Subject: Firmware Release Note: PS3 Font		Prepared by: T.Toriumi	
From: 1st Tech Service Sect., MFP/Printer Tech Service Dept.			
Classification:	<input type="checkbox"/> Troubleshooting	<input type="checkbox"/> Part information	<input type="checkbox"/> Action required
	<input type="checkbox"/> Mechanical	<input type="checkbox"/> Electrical	<input type="checkbox"/> Service manual revision
	<input type="checkbox"/> Paper path	<input type="checkbox"/> Transmit/receive	<input type="checkbox"/> Retrofit information
	<input type="checkbox"/> Product Safety	<input checked="" type="checkbox"/> Other (Firmware)	<input checked="" type="checkbox"/> Tier 2

Model: Be-C1.5		Date: 19-Mar-12	No.: RD154013
Subject: Change the default value of Accounting Counter		Prepared by: F. Noguchi	
From: 2nd Tech Service Sect., PP Tech Service Dept.			
Classification:	<input type="checkbox"/> Troubleshooting	<input type="checkbox"/> Part information	<input type="checkbox"/> Action required
	<input type="checkbox"/> Mechanical	<input type="checkbox"/> Electrical	<input checked="" type="checkbox"/> Service manual revision
	<input type="checkbox"/> Paper path	<input type="checkbox"/> Transmit/receive	<input typ

Example: Click charge contract in “5: square feet”

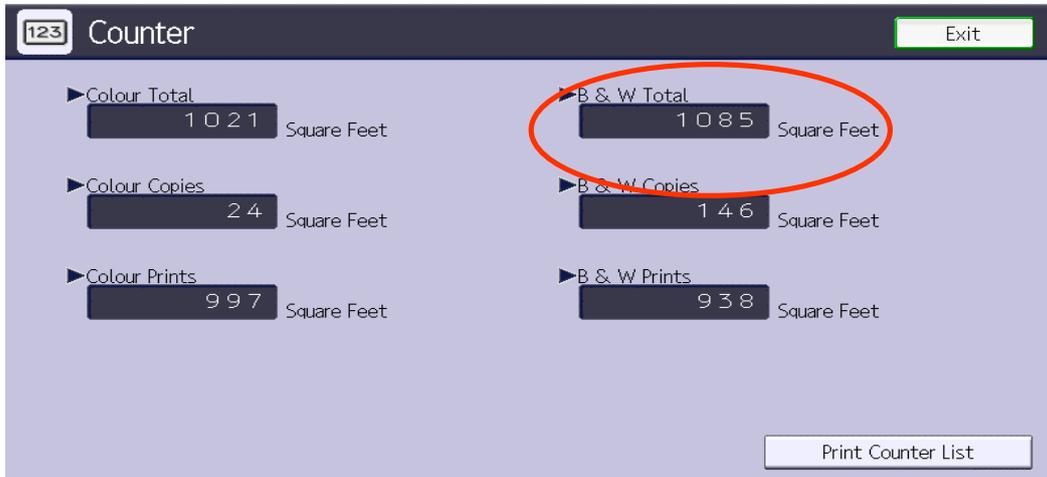
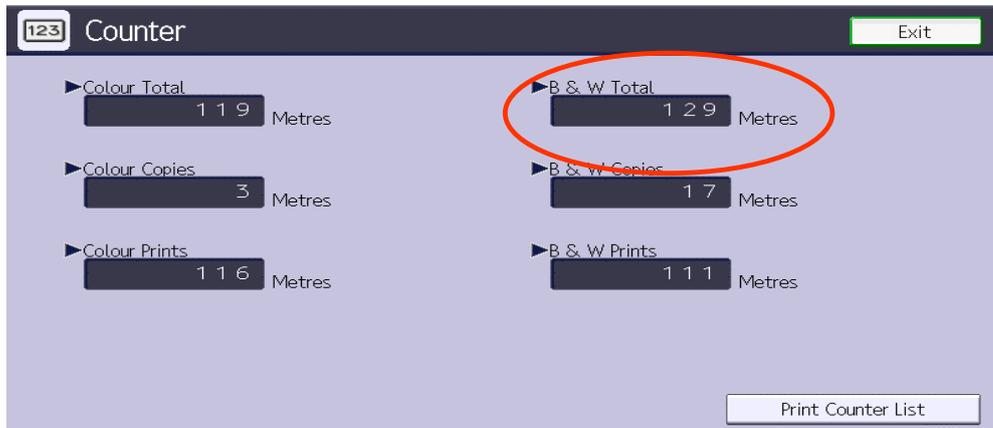
Accounting counter SP5045-002 is falsely rewritten as "0: meters" when devices are connected to @Remote center via Embedded @Remote to update the certificate information. This causes a discrepancy between the customer's service contract and the accounting counter setting.

B&W Total counter indicates the total print volume of the month as 1085 square feet.

The B&W Total counter unit indicates the total print volume of the month as 129 meters.

Click worth 956 square feet (1085-129) is not charged to your customer. This is because data sent from @Remote disregards unit of measure.

1. Contact your sales staff and obtain details of your customer’s service contract (click, annual service, price, etc.) and check if the contract corresponds with the accounting counter setting on the device (SP5045-002).
2. To correct the counter setting or to prevent future problems, perform the necessary actions by referring to the table below.

@Remote	Counter setting (SP5045-002)	Is counter setting corresponding with the contract?	Affected model	Actions
Embedded	"0" (meters)	Yes	ALL	Update the firmware on the next service visit.
		No	ALL	<ul style="list-style-type: none"> · Provide explanation of the problem to the customer and update the firmware. · Change the accounting counter setting SP5045-002 from "0 (meters)" to the unit of measurement according to your customer’s contract. · Connect to @Remote and confirm that the value in SP5045-002 remains corrected.
	Other than "0" (meters)	Yes	MPCW2200	Visit the customer site as soon as possible and update the firmware. (See NOTE below.)
			MPW7140/en MPW5100/en MPW3601 MPW2401	Update the firmware on the next service visit.
	No	ALL	Check if the accounting counter setting is correct. Make correction, if necessary.	
External or no @Remote	-	-	-	Update the firmware on the next service visit.
